<b>Title - Sujet</b> Furniture for PMPRB - 333 Laurier 1	
<b>Solicitation No. - N° de l'invitation</b> EP916-193099/A	<b>Amendment No. - N° modif.</b> 001
<b>Client Reference No. - N° de référence du client</b> 20193099	<b>Date</b> 2019-04-09
<b>GETS Reference No. - N° de référence de SEAG</b> PW-\$\$\$PQ-995-76791	
<b>File No. - N° de dossier</b> pq995.EP916-193099	<b>CCC No./N° CCC - FMS No./N° VME</b>
<b>Solicitation Closes - L'invitation prend fin</b> <b>at - à 02:00 PM</b> <b>on - le 2019-04-16</b>	<b>Time Zone</b> <b>Fuseau horaire</b> Eastern Daylight Saving Time EDT
<b>F.O.B. - F.A.B.</b> <b>Plant-Usine:</b> <input type="checkbox"/> <b>Destination:</b> <input type="checkbox"/> <b>Other-Autre:</b> <input type="checkbox"/>	
<b>Address Enquiries to: - Adresser toutes questions à:</b> Périard, Nathalie	<b>Buyer Id - Id de l'acheteur</b> pq995
<b>Telephone No. - N° de téléphone</b> (613) 324-8251 ( )	<b>FAX No. - N° de FAX</b> ( ) -

Amendment **001** is raised to publish questions and answers:

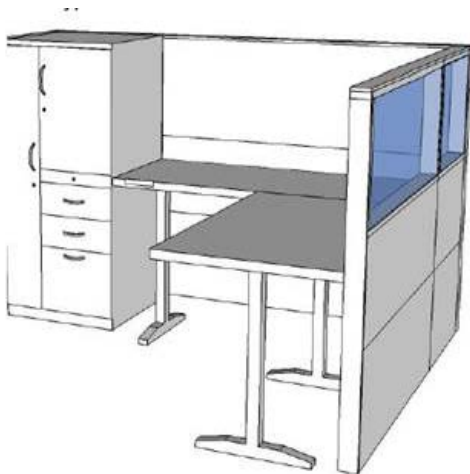
**Question no. 07:** Workstation typical **K** drawing shows panel type **L** with a fabric lower element and a frosted glass upper element; however, the panel descriptions calls for a Fabric lower and upper elements for panel type **L**. For the spec and pricing, do we follow the drawings of the panel descriptions? Or will they be corrected?

**Answer no. 07:** The drawing for typical K is incorrect, panel description L is correct. See sketch below for clarification:
